ADDENDUM NO. 1

LOTHIAN BOILER REPLACEMENT

PROJECT NO. 956401

Subject: UCR Lothian Boiler Replacement - Addendum #1

SK-1
pg. 1 OF 3

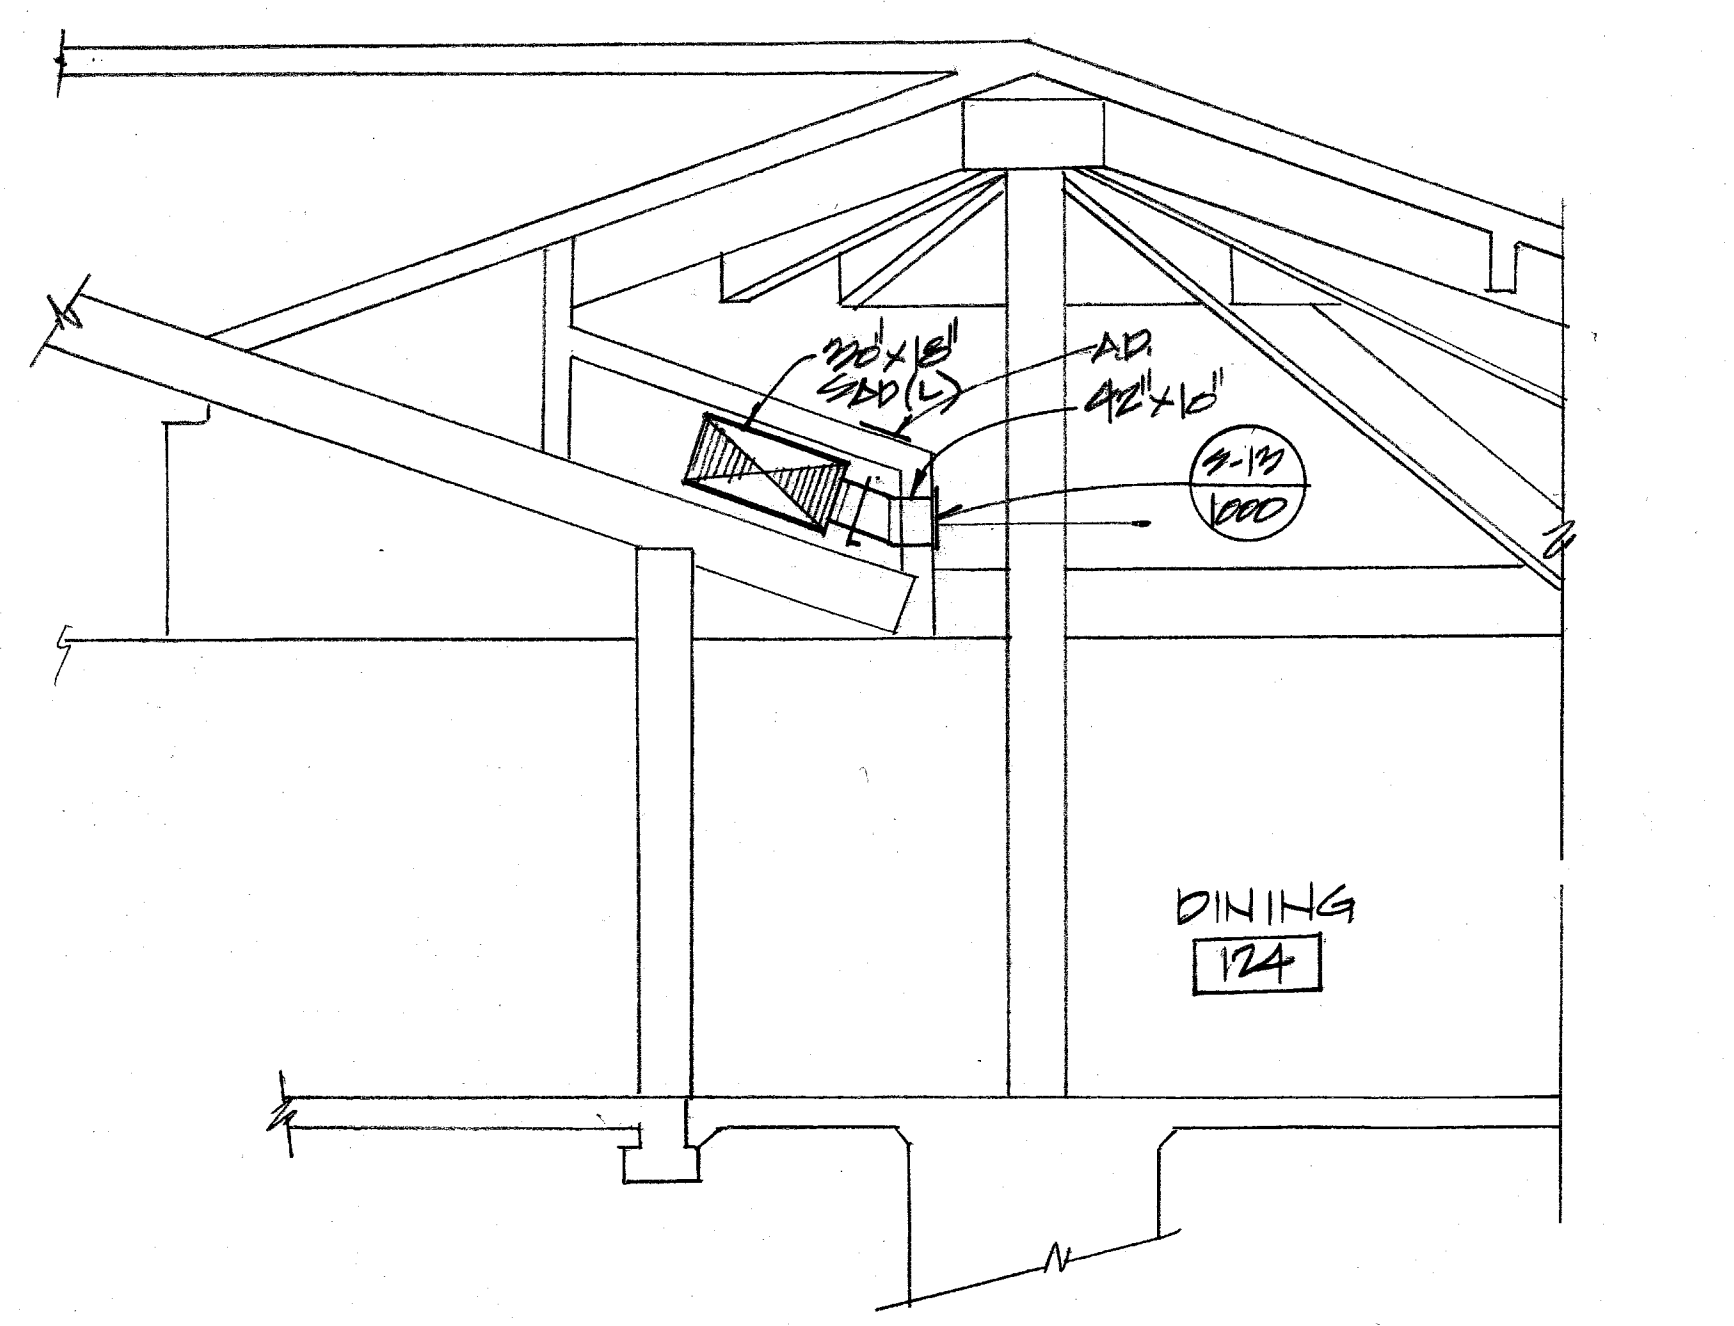
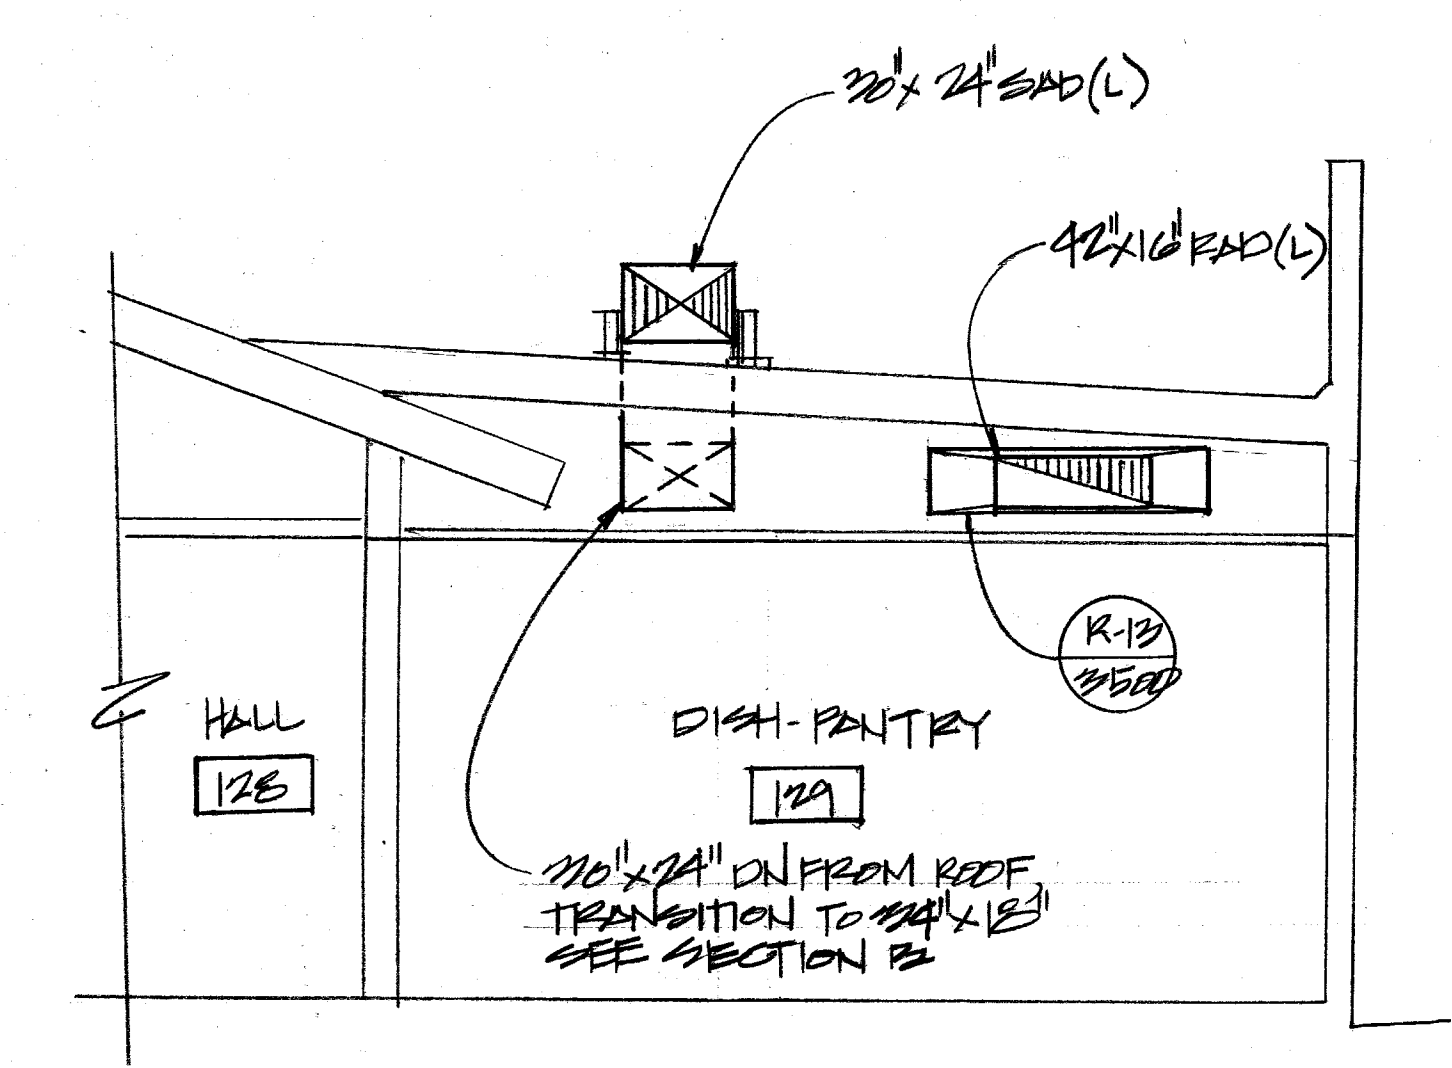
1. As-built drawings provided to show existing boiler flue stack offset locations and roof penetration detail. Existing flues shall be replaced with new Category IV flues.
